### SPECIAL DISTRICTS APPLICATION

Change of use from office to traveler's accommodation, lodging, for the first 9 floors, including portions of the lobby space, and 450 sf of outdoor dining area on ground floor

### **One South Church Hotel**

# 9 CHURCH

SITE PLAN SHEET 02 OF 07

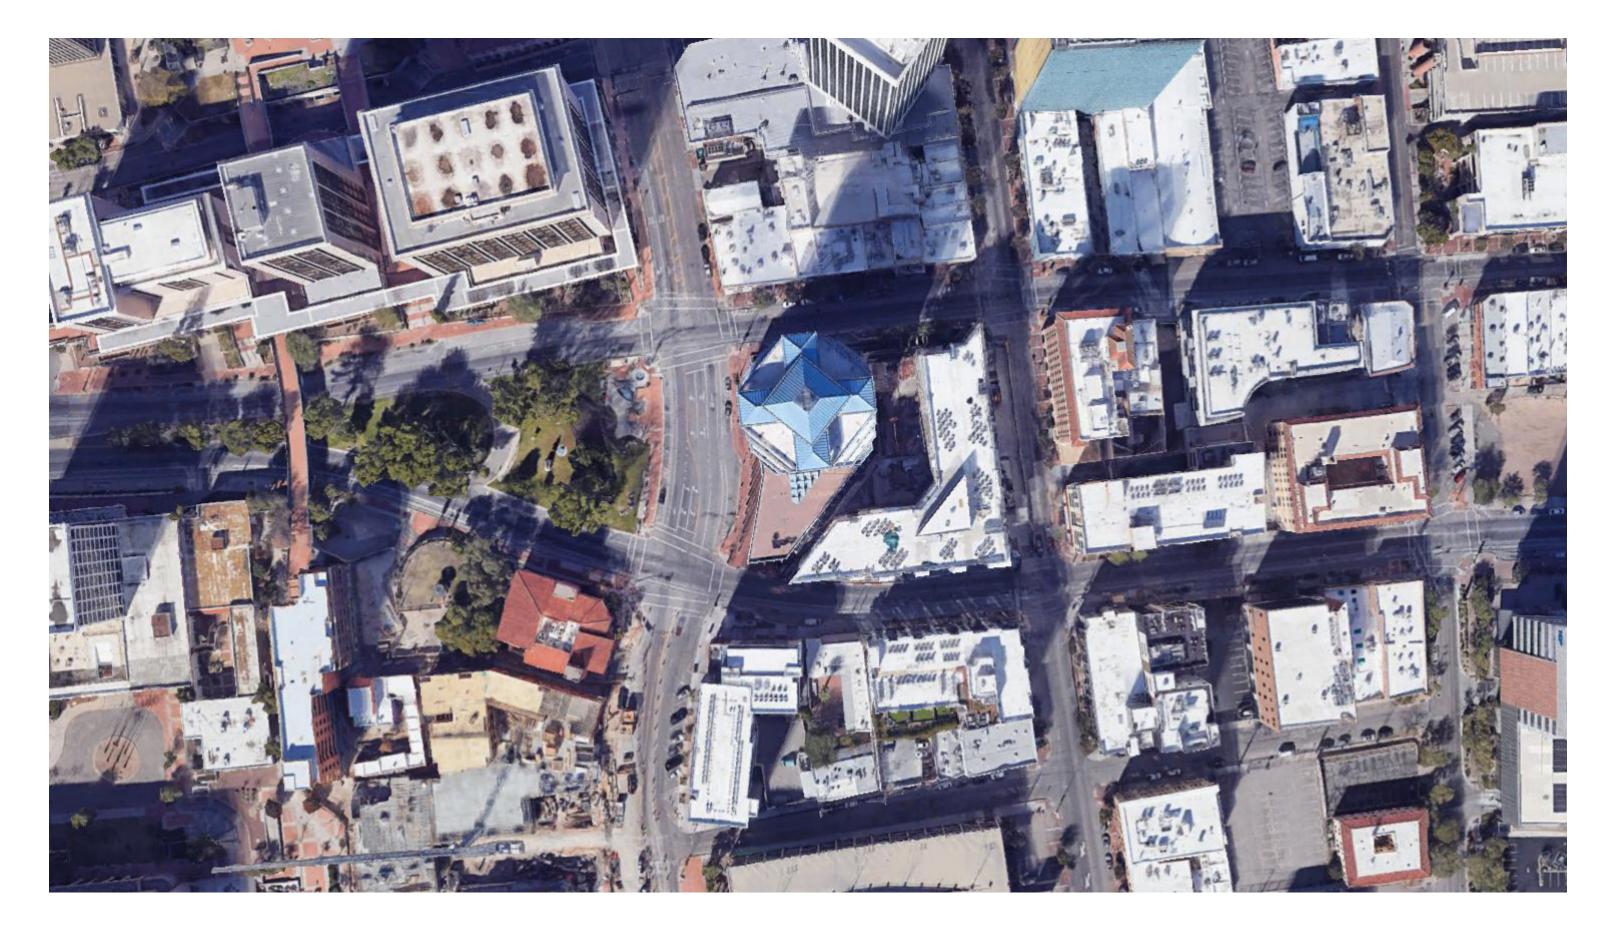
Task End Date	Reviewer's Name	Type of Review	Description	Status	Comment
					4. 2-06.4.7.A.4 - The proposed "HOTEL" use should be listed as "TRAVELERS ACCOMMODATION, LODGING".

5. 2-06.4.7.A.6.a - As this site is located within the down town core and the Rio Nuevo Area (RNA) and you are proposing an exterior patio RNA & Historic review may be required. Contact Maria Gayosso, Maria.Gayosso@tucsonaz.gov for requirements and process.

6. 2-06.4.7.A.6.b - If RNA or Historic review is required provide the case number adjacent to the title block on all sheets.
					2-06.4.7.A.8 - For development package documents provide:

7. 2-06.4.7.A.8.a - Provide the floor area for the proposed patio on the plan.
					2-06.4.9 - Information on Proposed Development  The following information on the proposed project shall be shown on the drawing or added as notes.

8. 2-06.4.9.Q - Provide the square footage of the proposed patio within the footprint on the plan.
					9. 2-06.4.9.W - All signage will require a separate review and permit.
					If you have any questions about this transmittal, please Steve Shields, (520) 837-4956 or Steve.Shields@tucsonaz.gov
					RESUBMITTAL OF THE FOLLOWING IS REQUIRED: Revised development package
nowing 11	to 19 of 19 e	ntries			Previous 1 2 Next
